Testimony for LU 16-159330 LDS EN, 5920 SW 48th, Hayhurst NA appeal returning to Council on Aug. 9.

632.100 Landslide Hazard Area Approval Criteria  
LU Case #LU 16-159330 LDS EN

Re: LU 16-159330 LDS EN, Everett Homes development in Hayhurst Neighborhood

SUBJECT: Stormwater comments for LU 16-159330 LDS EN (Everett Heights)

FIGURE 3

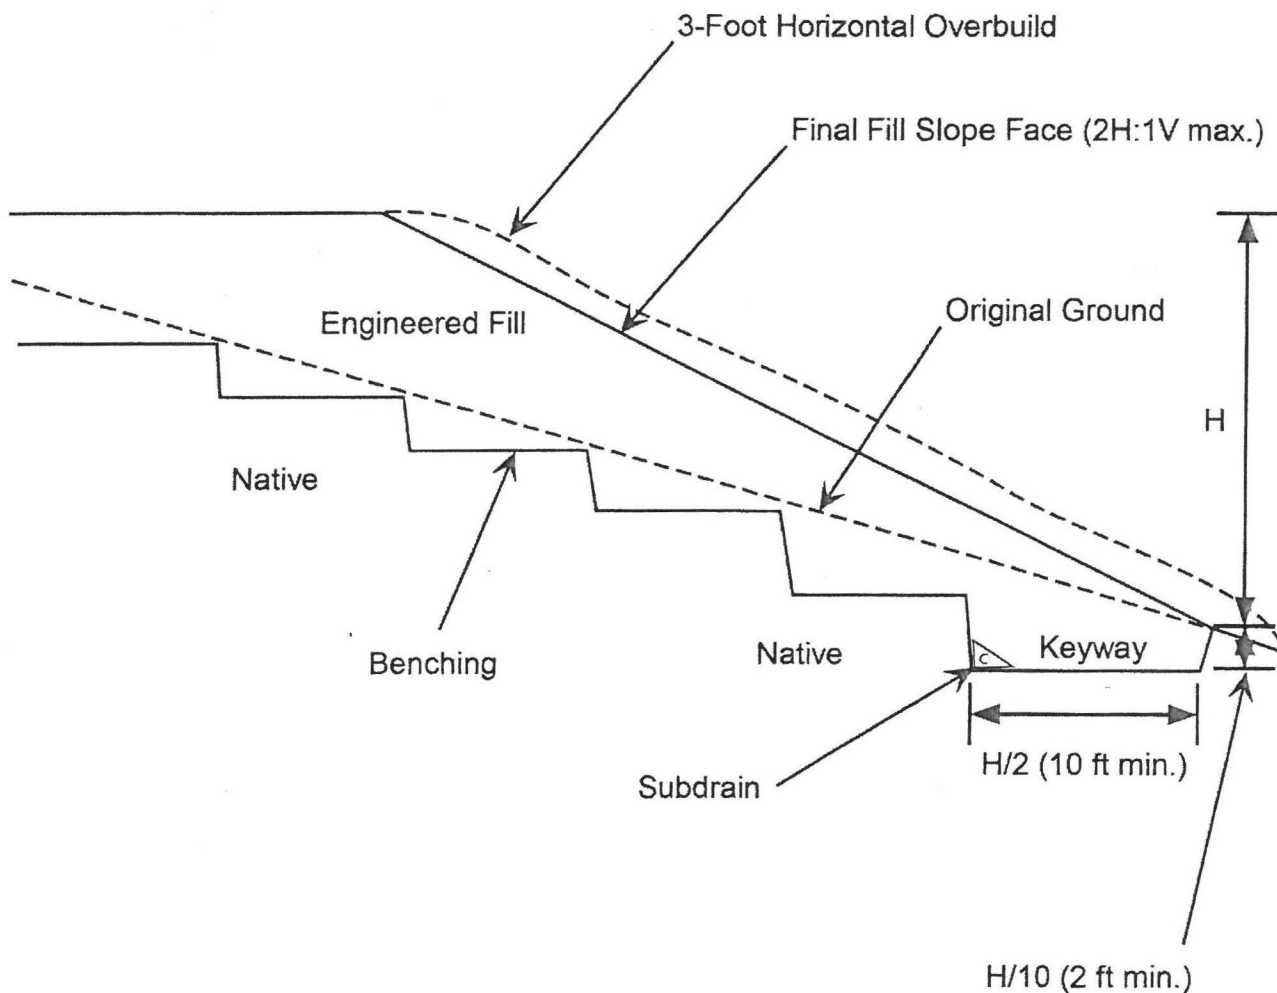
In the applicant's Landslide Hazard Study, water is planned to be collected in two locations. Water will be collected in a drain pipe at the toe of the 17' of fill and in a drain pipe at the base of the 6' tall 220' long wall. See attached Figure 3 of HGSI report. The applicant plans to dispose of this un-estimated amount of water into the environmental zone without treatment. Please see the Hearings Officer Decision last paragraph Page 20 on this:

The applicant did not estimate the amount of water that will be drain from the fill area and the amount of water that will drain from behind the 6' tall 220' long retaining wall and be collected into pipes that will drain into the environmental zone.

The top of page 37 of the Hearings Officer's Decision summarizes the applicant's stormwater management methods for Public Street Improvements and for Lots. However, the applicant's Conceptual Stormwater Management Report does not include the drain pipes at the base of the wall and at the toe of the filled area. No facilities have been designed to collect or treat water collected from these areas. No facilities to collect or treat water collected from these areas are shown on the

subdivision plans or are included in the applicant's Conceptual Stormwater Management Report. Therefore the applicant has not shown that a stormwater management system can be designed that will provide adequate capacity for the expected amount of stormwater because nothing has been designed for the water from the drain pipes at the base of the wall and at the toe of the filled area. Therefor the standards and criteria of 33.653.020 B. has not been met.

The applicant's Conceptual Stormwater Management Report does not include the drain pipes at the base of the wall and at the toe of the filled area. No facilities to collect or treat water collected from these areas are shown on the subdivision plans or are included in the applicant's Conceptual Stormwater Management Report. Therefore the Bureau of Environmental Services has not reviewed nor has the applicant looked into the capacity, type, location, feasibility and land area required of the proposed stormwater management system and stormwater disposal facilities as well as any connection to off-site facilities from the filled area and from the base of the wall. Therefor the standards and criteria of 33.653.030 has not been met.
